NUMBER: 23-043-20

Headlamp Condensation and Fogging

This bulletin involves installing updated closure(s) cap on the headlamp assembly.

2015 - 2020 (LD) Dodge Charger

Fig. 4
Closure Cap Installed

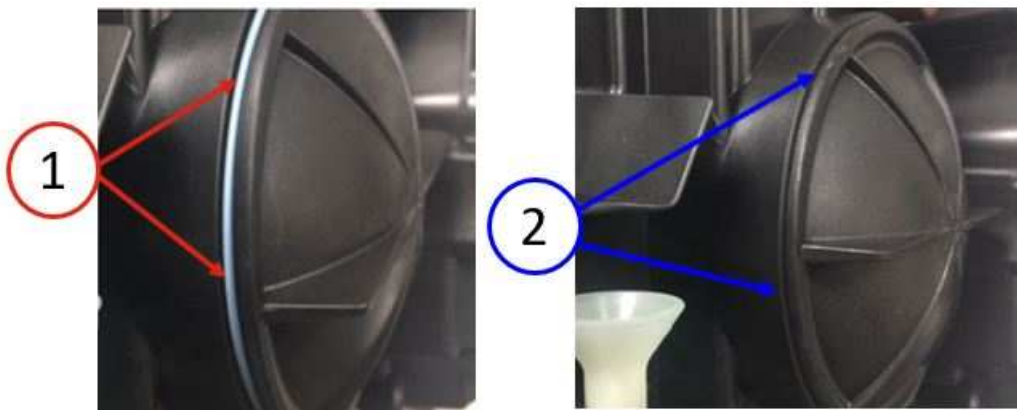
NOTE: Make sure the Closure cap(s) are properly installed. If the seal on the cap is visible, it is not installed properly (Fig. 4) .

3. Install the new closure cap(s) by turning the cap clockwise. Make sure the cap is fully seated and all lugs are engaged.

1 - Closure Cap Not Installed Properly

2 - Closure Cap Installed Properly
